Supplement

#112422 - 2 23 2023

:: #81589 RC8B4 FT Chassis, RWB

Radio Tray Configuration:

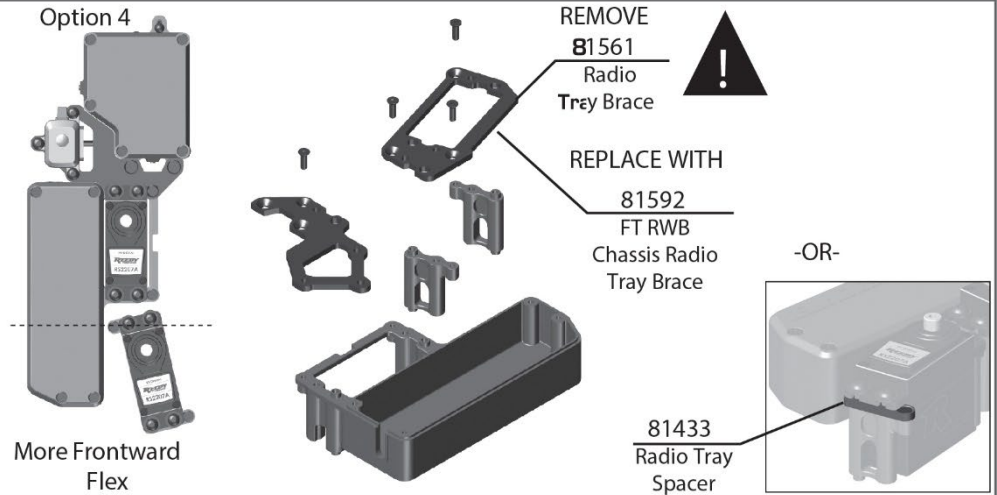
- 1) Running the chassis requires eBuggy center driveshafts (#81580, #81581)
 - #81580, 93.5mm front
 - #81581, 104mm rear
 - 2) Remove #81561 Radio Tray Brace
 - More Flex: Install #81433 radio tray spacers (see option 4 from the manual)
 - OR-
 - Less Flex: Install #81592 FT RWB Radio Tray Brace (+10mm)
- 3) Body Trimming:
You will have to re-trim the engine cut out and fuel window opening 10mm rearward now that the engine and fuel tank are shifted to the back.
